Re: GASCO Production Company
Gate Canyon State #12-21-11-15
1793' FNL and 717' FWL
SW NW Sec. 21, T11S - R15E
Duchesne County, Utah

APPLICATION FOR PERMIT TO DRILL		5. MINERAL LEASE NO.: ML-49308	6. SURFACE: State
1A. TYPE OF WORK: DRILL <input checked="" type="checkbox"/> REENTER <input type="checkbox"/> DEEPEN <input type="checkbox"/>		7. IF INDIAN, ALLOTTEE OR TRIBE NAME: N/A

**DIVISION OF OIL, GAS AND MINING
APPLICATION FOR PERMIT TO DRILL
STATEMENT OF BASIS**

LOCATION LAYOUT FOR

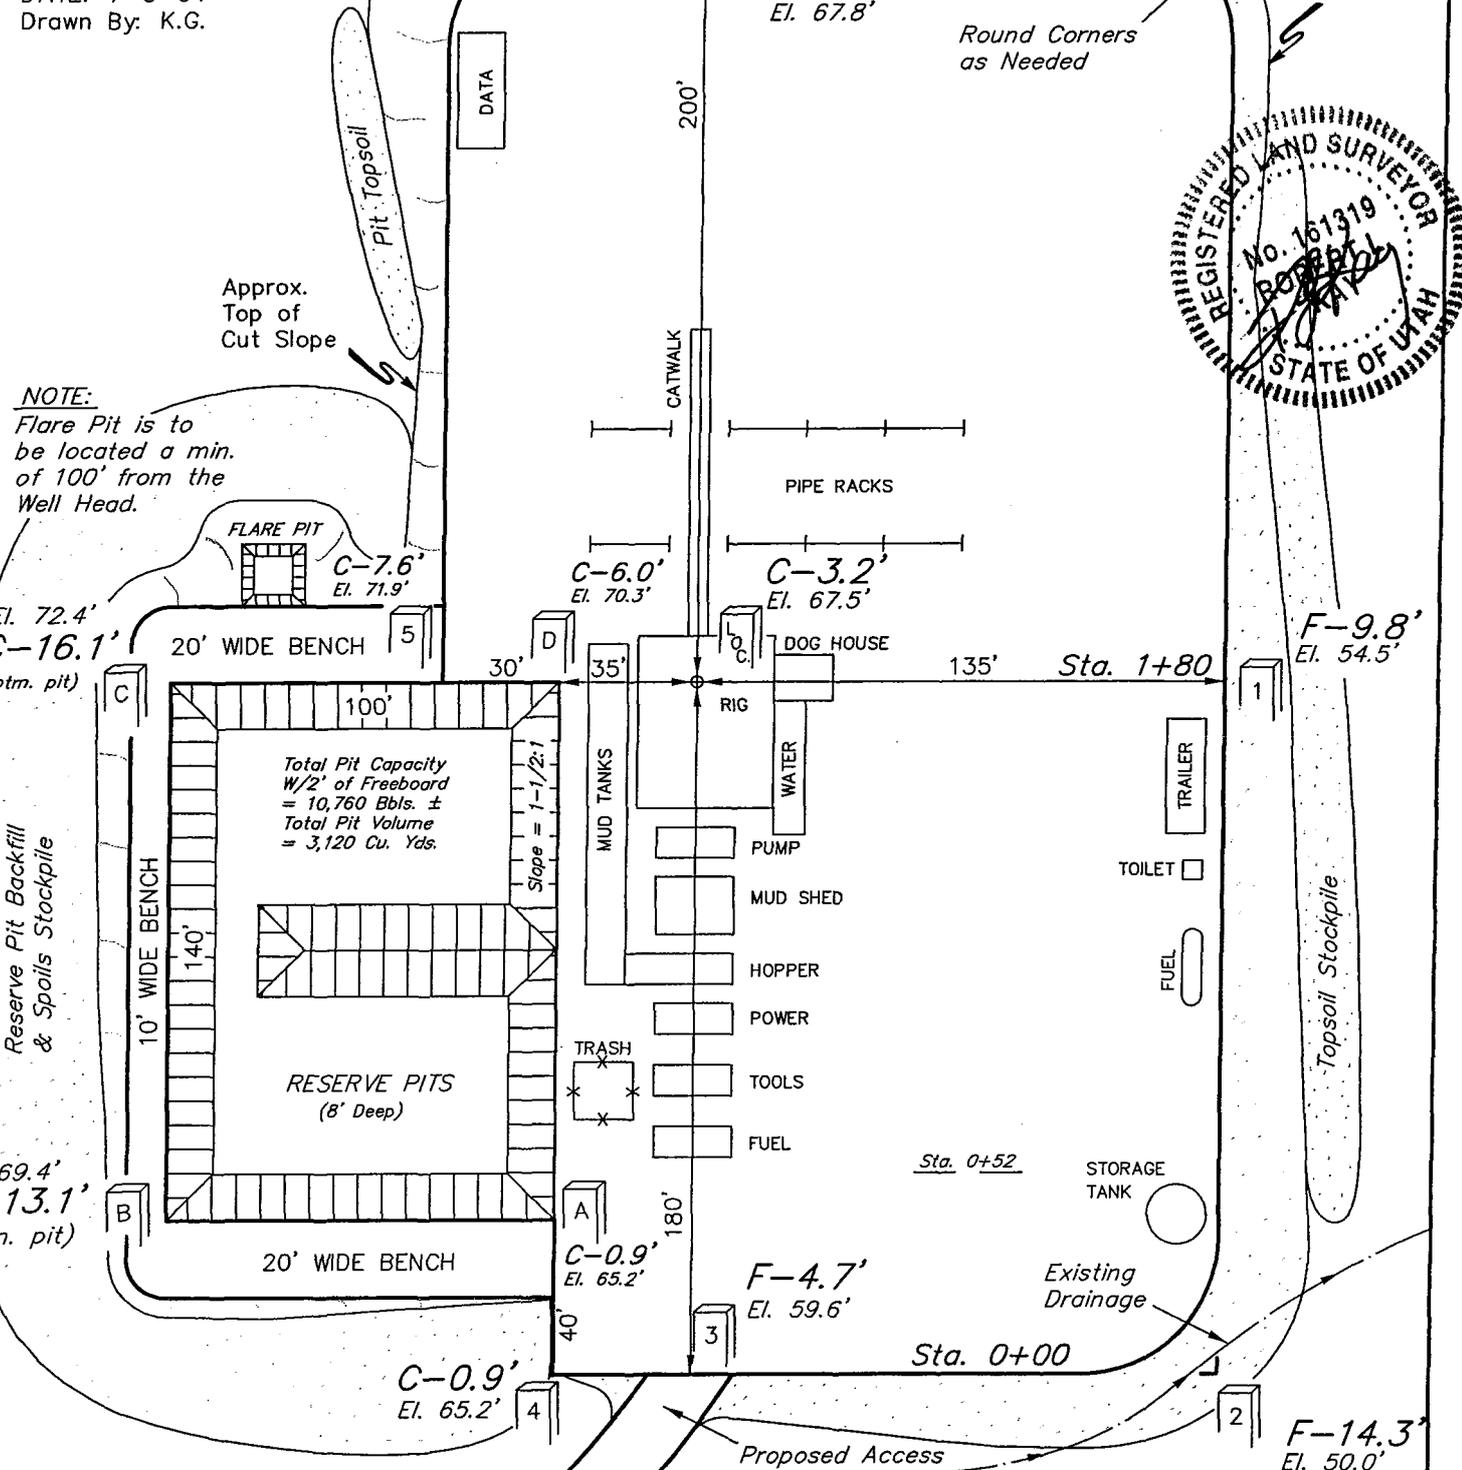
The reserve pit was staked on a narrow north/south ridge that slopes or dips west toward the access road and Gate Canyon, leaving the rig pad at the western edge of a large flat. However, underlying sandstone will most likely require that blasting be done to construct the pit and, therefore, a liner and felt pad is mandatory. This location was staked within the 200 foot window and doesn't appear to provide any problems with stability or construction.

1. A synthetic liner with a minimum thickness of 12 mils with a felt subliner shall be properly installed in the reserve pit.

Casing Schematic

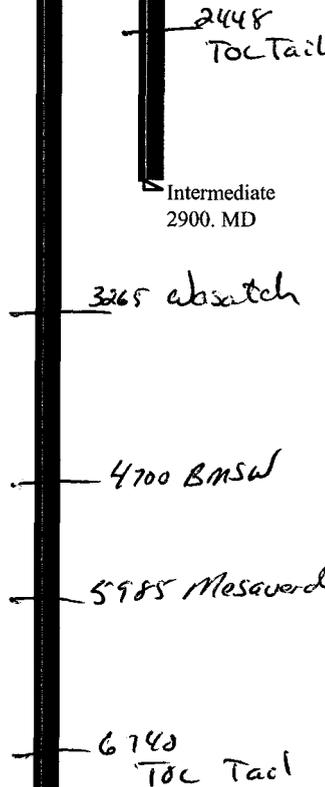
$$(.052)(9.5)(11,300) = 5582$$

11ppg = Max Anticipated 6463

$$(.12)(11,300) = 1356$$

5108 psi

MAWP = 4226

Gas Mod MAWP 3977 psi

BOPE - 5,000 ✓

Surf casing 1730

$$70\% = 1211$$

Test to 1200 psi ✓

Int - 3520

$$70\% = 2464$$

Test to 2400 psi ✓

Adequate
